Access Compliance Report Public Rights-of-Way (Curb Ramps)

Intersection ID: 10033789 Main Street: PACIFIC ECHO DR Cross Street: N/A Location: NW ADA ID: D6D46758C8A7 Ramp Type: Perp Initial Pass/Fail: Fail **Overall Compliance: No Severity Score:** 22.5

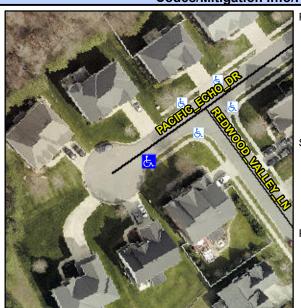
Possible Solutions: Remove & Replace Entire Ramp. Surveyor Notes: N/A PROW/ADA: Not Found, R304.5.1, R304.2.2, R304.5.3

Field Measurements/Component Compliance								
Compl	iance Description	Data	Compl	iance	Description	Data		
N/A	Ramp Length (in)	49.0	No	Ramp	Slope (%)	9.5		
No	Ramp Width (in)	47.0	No	Ramp	XSlope (%)	2.9		
N/A	Flare Type LT	N/A	N/A	Flare Type RT		N/A		
N/A	Flare Slope LT (%)	N/A	N/A	Flare Slope RT (%)		N/A		
N/A	Flare Traversable LT?	N/A	N/A	Flare Traversable RT?		N/A		
N/A	Landing Length (in)	N/A	N/A	DWS	Provided?	N/A		
N/A	Landing Width (in)	N/A	N/A	DWS	Contrast?	N/A		
N/A	Landing Slope (%)	N/A	N/A	DWS	Length (in)	N/A		
N/A	Landing X Slope (%)	N/A	N/A	DWS	Full Width?	N/A		
N/A	Landing Curb? (Y/N)	N/A	N/A	DWS	Offset (in)	N/A		
N/A	Shared Landing?	N/A						
N/A	Gutter Ponding?	N/A	N/A	Gutte	er Slope (%)	N/A		
N/A	Gutter Lip Ht (in)	N/A	N/A	Gutte	r X Slope (%)	N/A		
N/A	Painted X Walk1?	No	N/A	Paint	ed X Walk2?	N/A		
	X Walk 1 Direction	To NW		X Wa	lk 2 Direction	N/A		
N/A	X Walk 1 Width (in)	N/A	N/A	X Wa	lk 2 Width (in)	N/A
